File FPP-1995-104

Project Name: 15th & Wellington

REVIEW COMMENTS

TITLE HEADING: Final Plat/Plan -
Wellington Gardens,
Filing #1

WELLINGTON GARDENS
 COMPOSITE PLAN

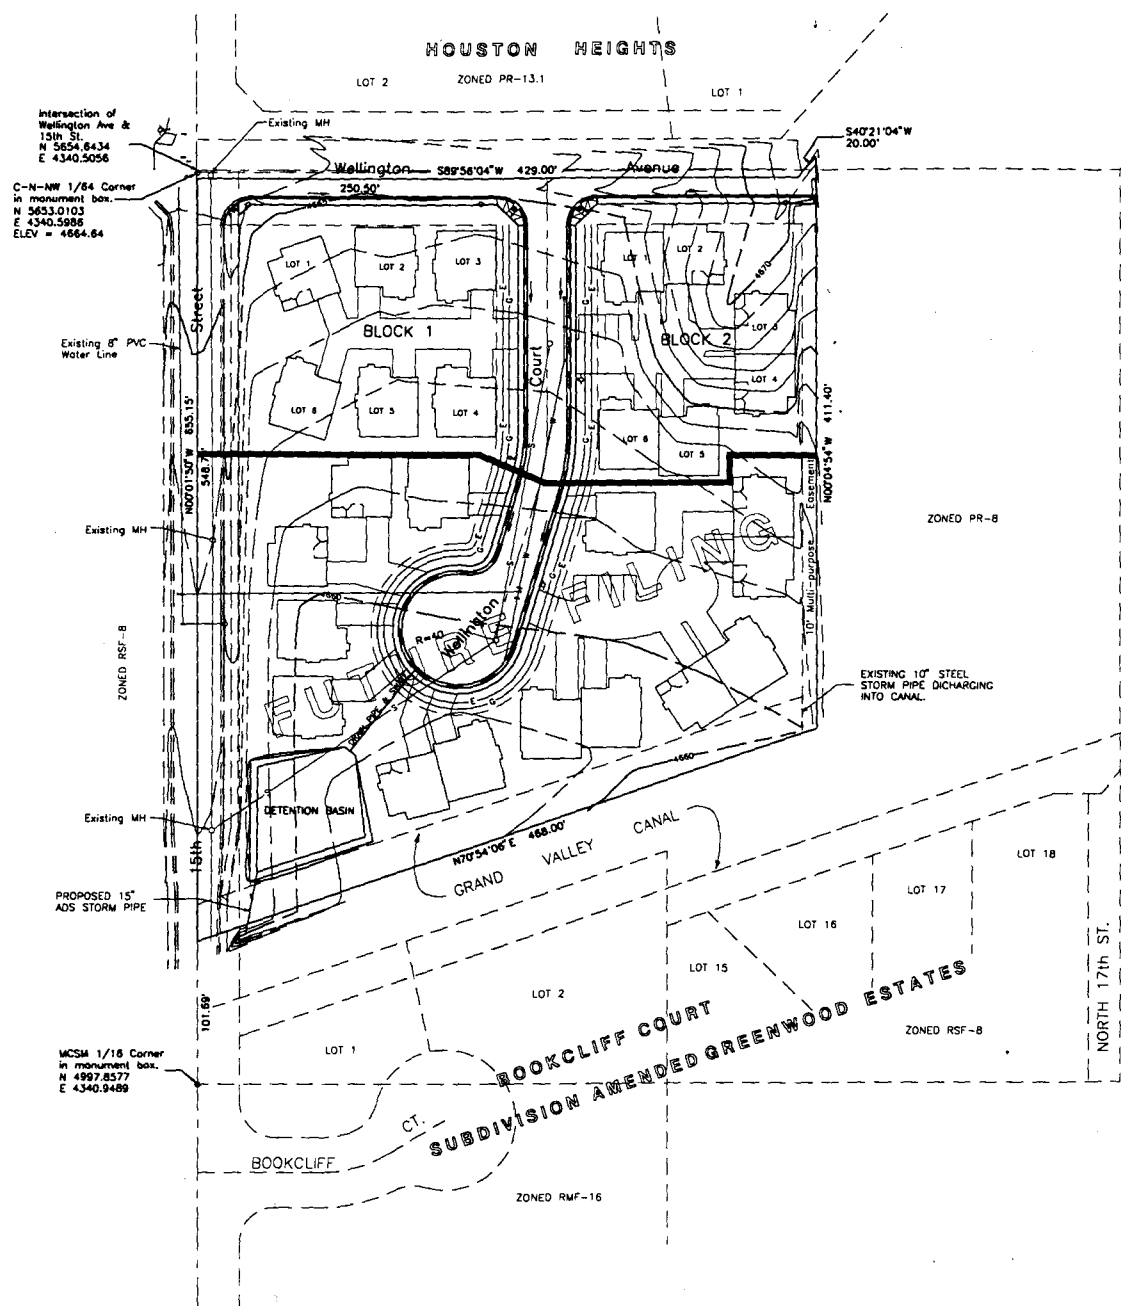
Composite Plan
